VCR 98-02

Hitachi Home Electronics (America), Inc.
National Service

MODELS: VT-MX221A (U71032889), VT-MX421A (U71066989),
VT-MX421AC (U71013401), VT-FX601A (U71005401),
VT-MX424A (U71018989)

SUBJECT: INSTALLATION OF KIT, PART NUMBER X480195

Figure 1

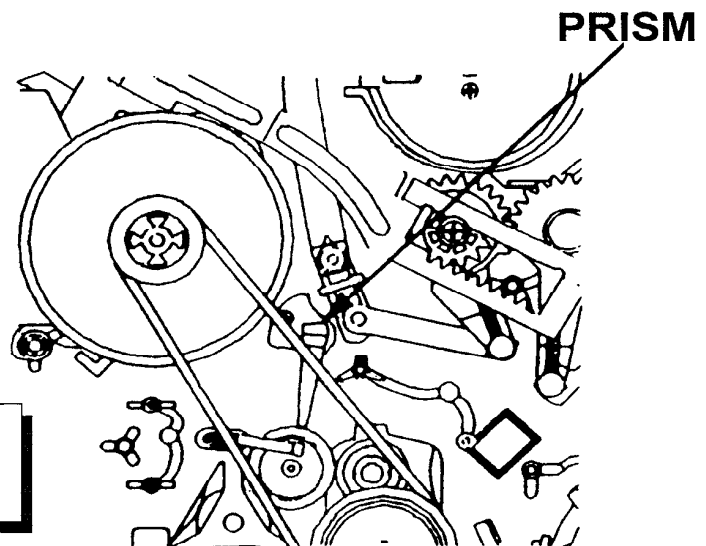
SYMPTOM: Within 15 seconds, unit shuts-OFF & Indicator indicates
ERROR CODE #1

- 1.) Replace the Prism (Shown in Fig. 1) on the Deck Mechanism with the new one.
- 2.) Replace D511 with new one.

CAUTION: Please pay attention to the following when replacing D511.

- a) Do NOT apply any mechanical stress to the leads.
- b) Solder in D511 quickly, do NOT apply excessive heat.
